Project BLACKTOWN WORKERS SENIORS LIVING - INDUSTRIAL PARK ROAD ANDRELL PARK NSW	Scale As indicated @A1	Drawing Title MASTERPLAN - SECTIONS - SHEET 1	Issue B
Client Paynter Dixon www.paynter-dixon.com.au	Author AJ+C ALVIN JENNY COTTELL 79 Maple Street, Chippendale NSW 2008 AUSTRALIA ph +61 2 8511 8222 fax +61 2 8511 8200 ABN 53 003 762 250	Sheet Status NOT FOR CONSTRUCTION	Project No. 17002

Project	BLACKTOWN WORKERS SENIORS 170 RESERVOIR ROAD ANNIELL PARK, NSW	Scale	1:200 @A1	Drawing No.	DA2100 D																									
Architect	AJ+C 78 Maple Street, Chesham NSW 2869 AUSTRALIA PH +61 2 8311 8221 x +61 2 8311 5200 ABN 53 003 762 250	Drawing Title	STAGE 1 - LEVEL 1 (GROUND) PLAN																											
Client	PAYNTER DIXON CREATING SINCE 1914 www.paynterdixon.com.au	Drawing Scale	NOT FOR CONSTRUCTION																											
Key																														
Revisions

BLACKTOWN WORKERS CLUB SENIORS LIVING

MASTERPLAN REPORT - LANDSCAPE

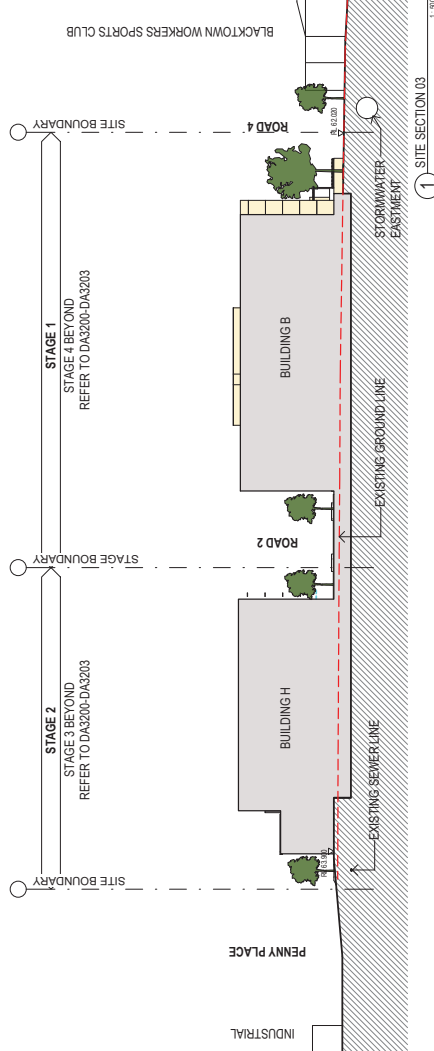
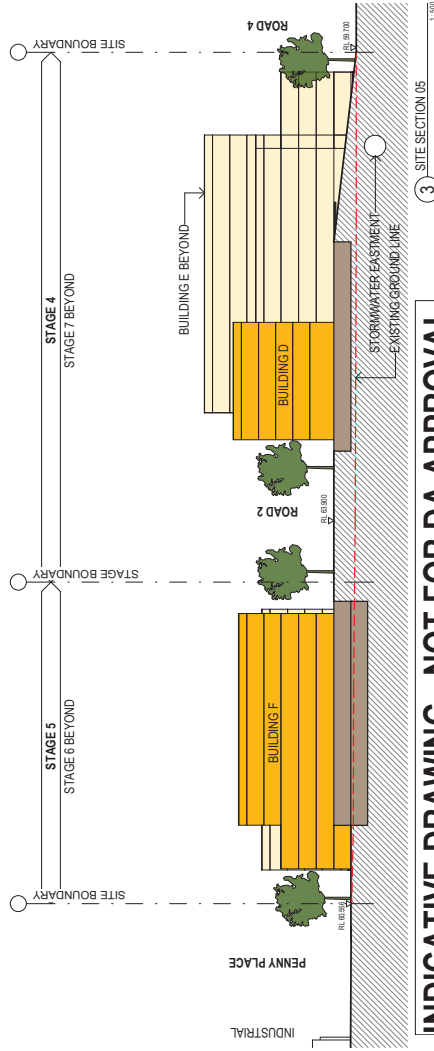
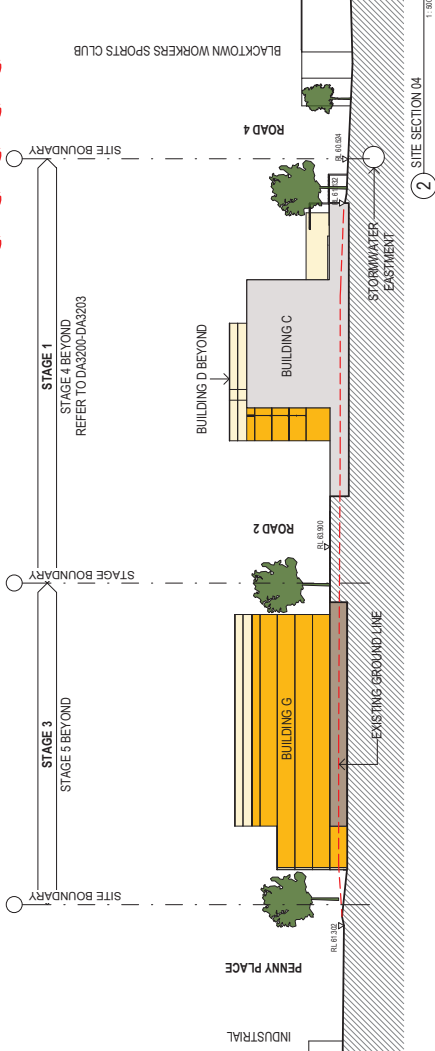
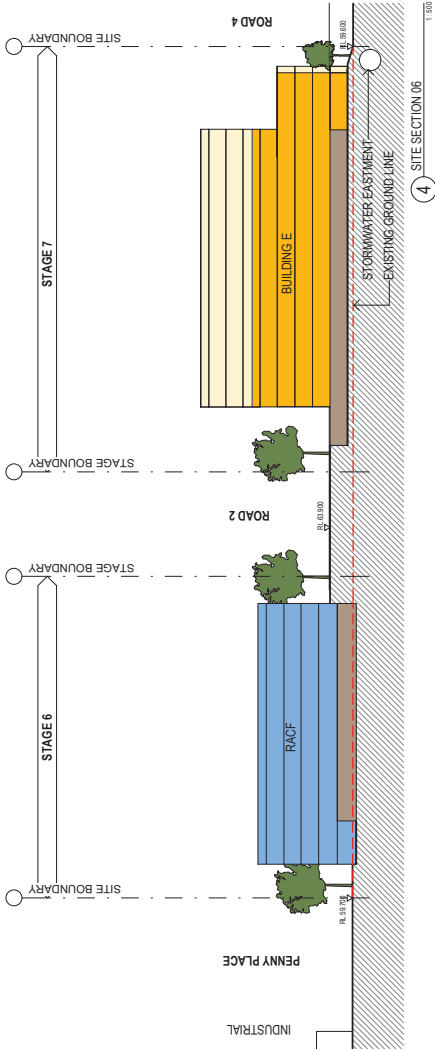
DA MODIFICATIONS - SECTIONS:
1. COLOR CODE ADDED TO DIFFERENTIATE BETWEEN
APARTMENTS, BASEMENTS AND LANDSCAPED WALLS

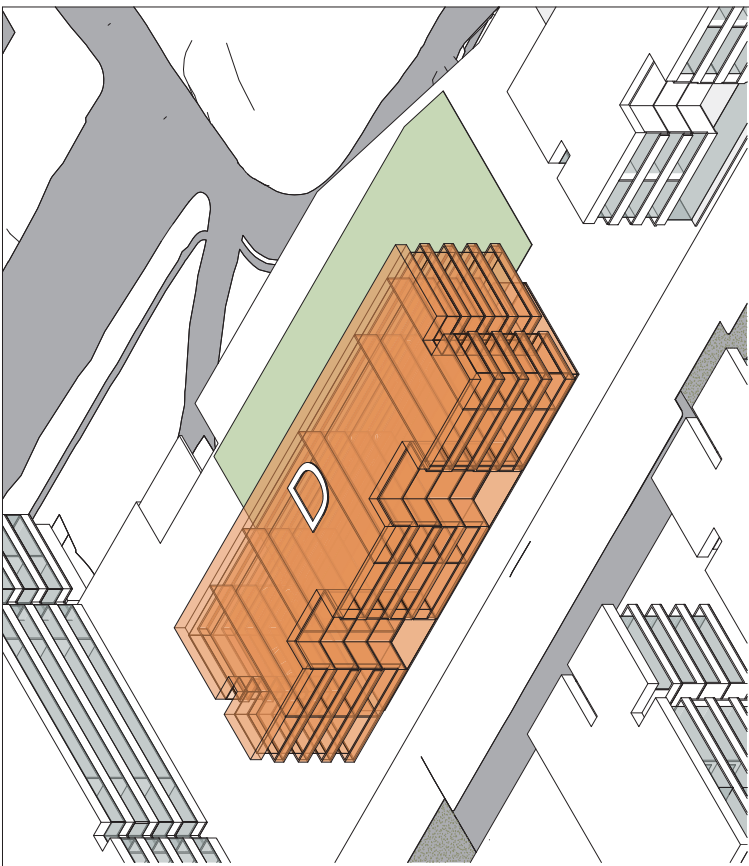
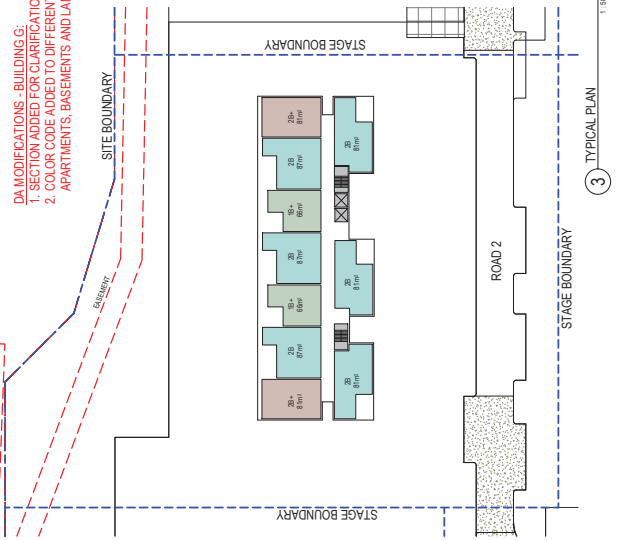
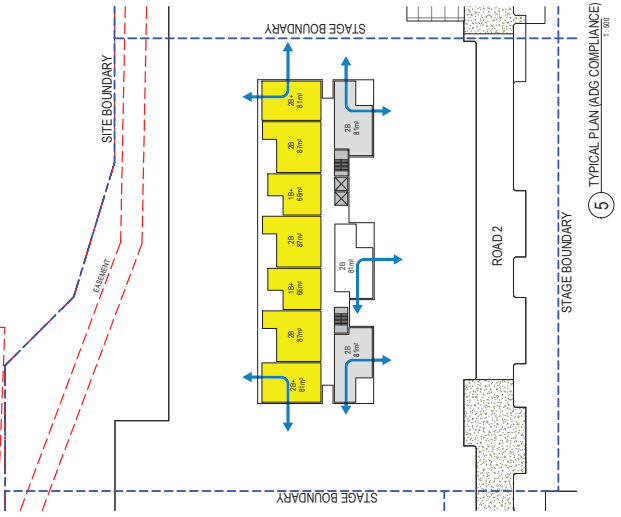
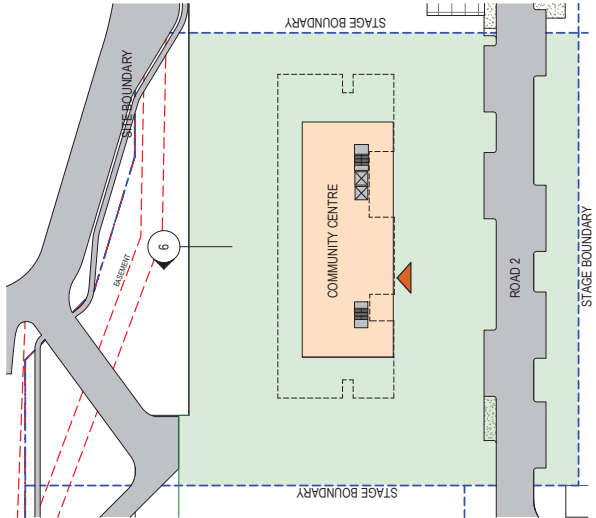
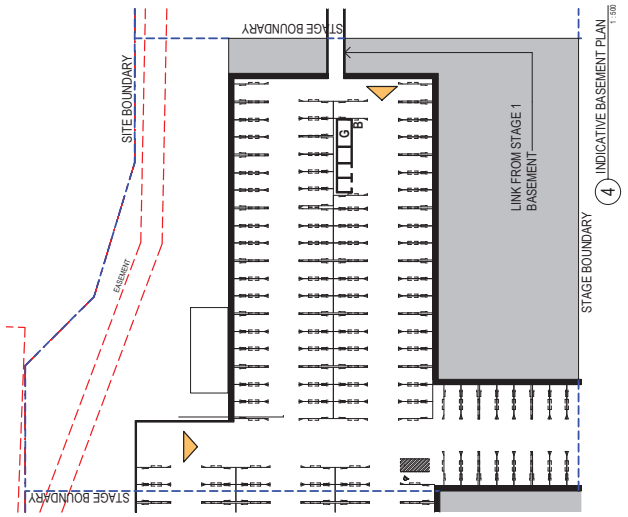
DA MODIFICATIONS - BUILDING G:
1. SECTION ADDED FOR CLARIFICATION
2. COLOR CODE ADDED TO DIFFERENTIATE BETWEEN
APARTMENTS, BASEMENTS AND LANDSCAPED WALLS

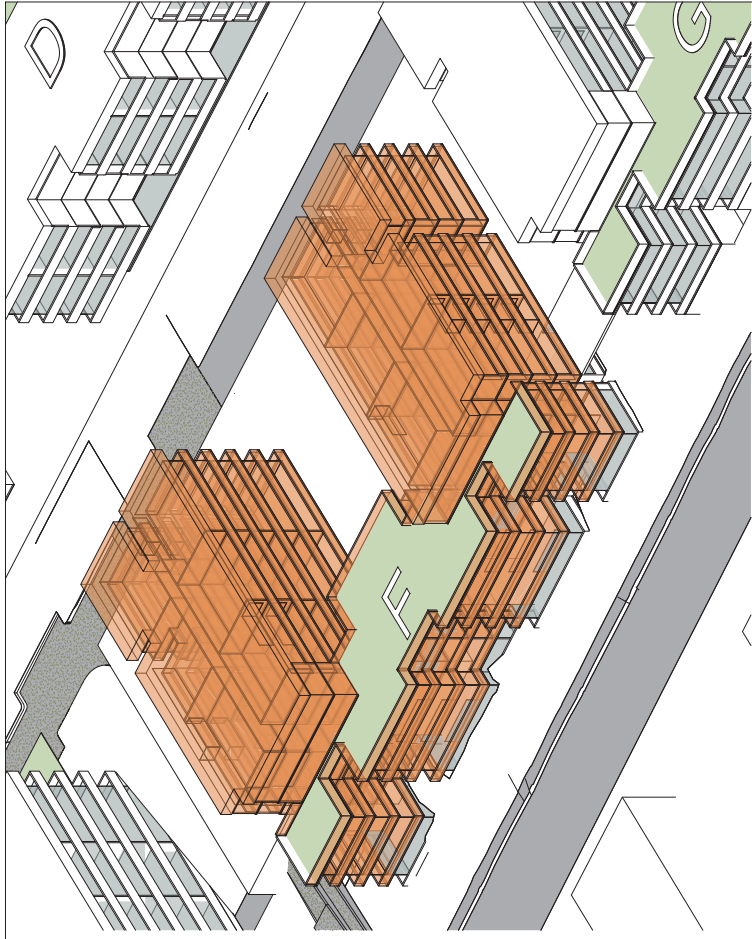
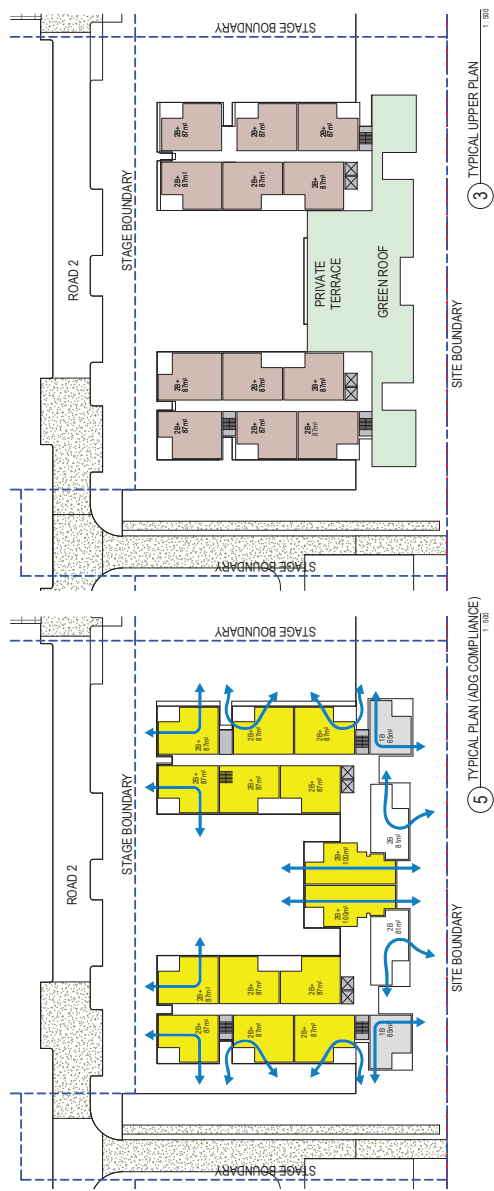
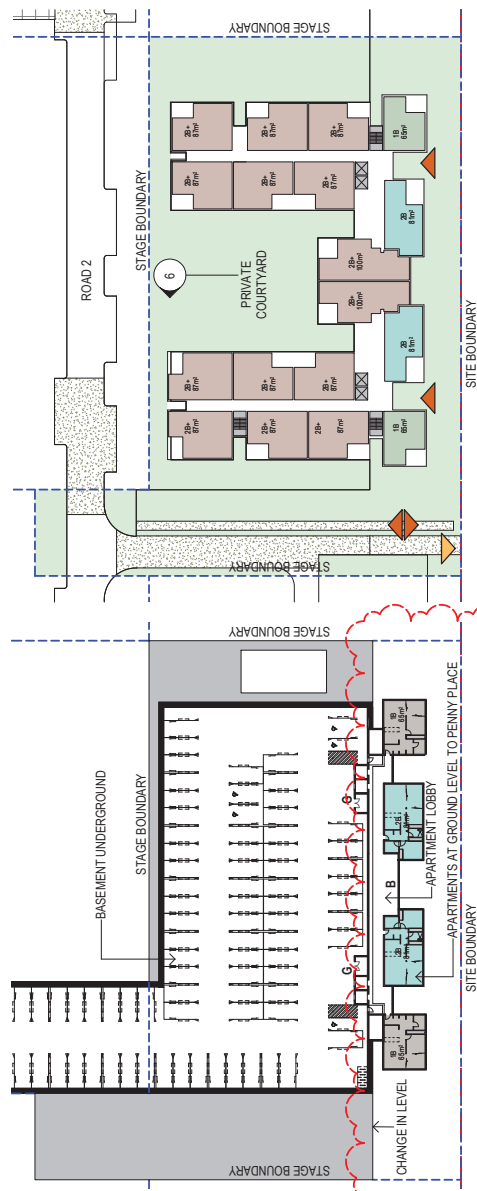
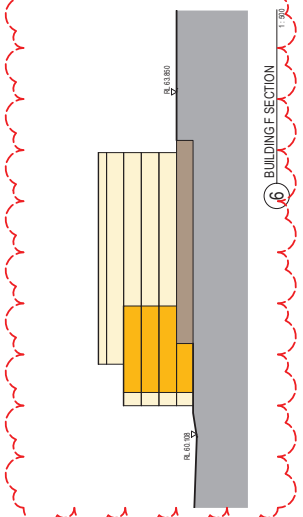
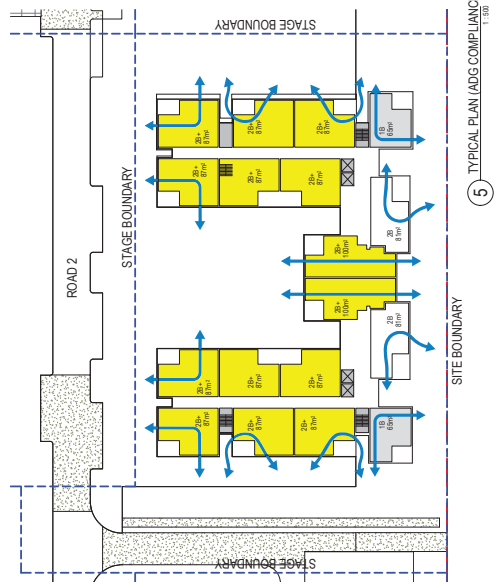
- DA MODIFICATIONS - BUILDING G:**
1. SECTION ADDED FOR CLARIFICATION
 2. COLOR CODE ADDED TO DIFFERENTIATE BETWEEN APARTMENTS, BASEMENTS AND LANDSCAPED WALLS
 3. NOTES ADDED FOR CLARIFICATION

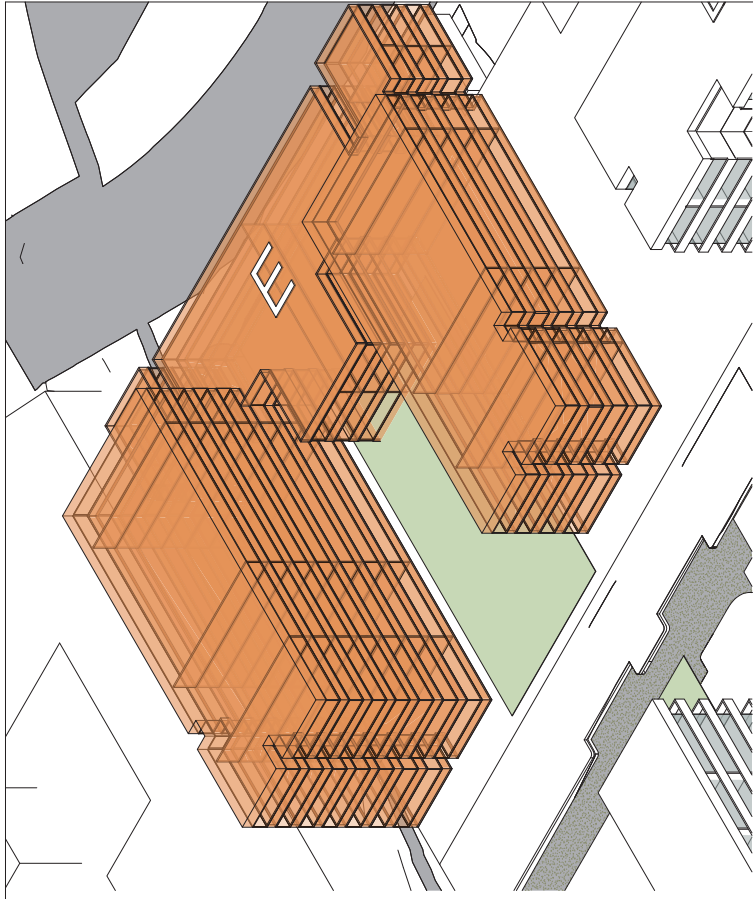
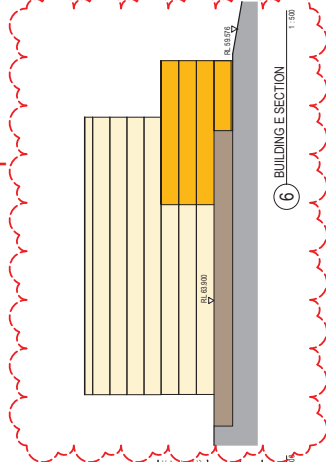
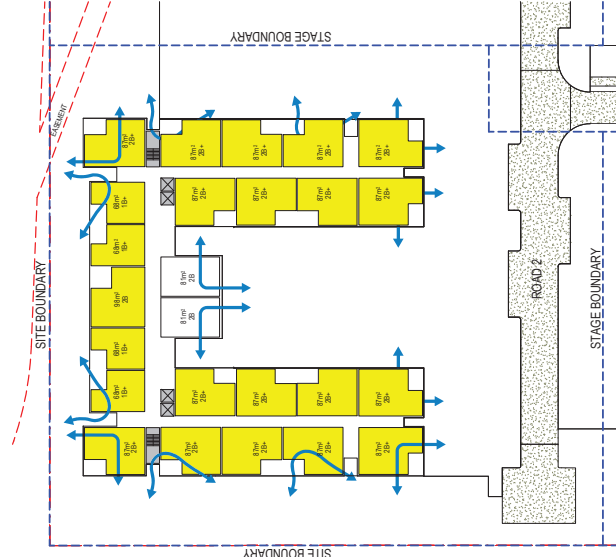
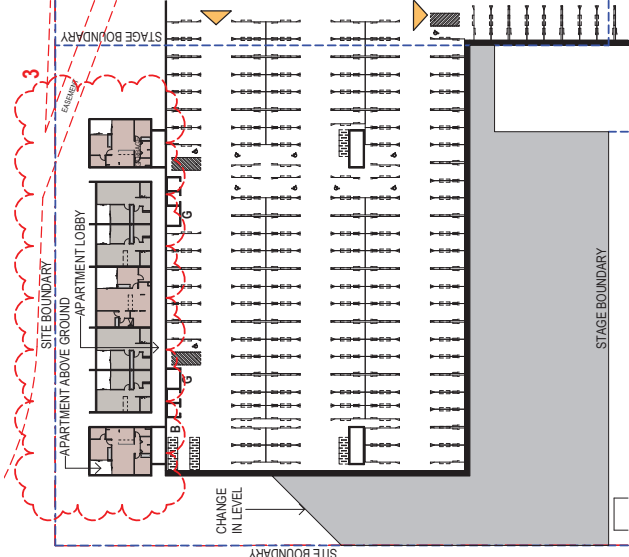
- DA MODIFICATIONS - BUILDING G:**
1. SECTION ADDED FOR CLARIFICATION
 2. COLOR CODE ADDED TO DIFFERENTIATE BETWEEN APARTMENTS, BASEMENTS AND LANDSCAPED WALLS
 3. NOTES ADDED FOR CLARIFICATION
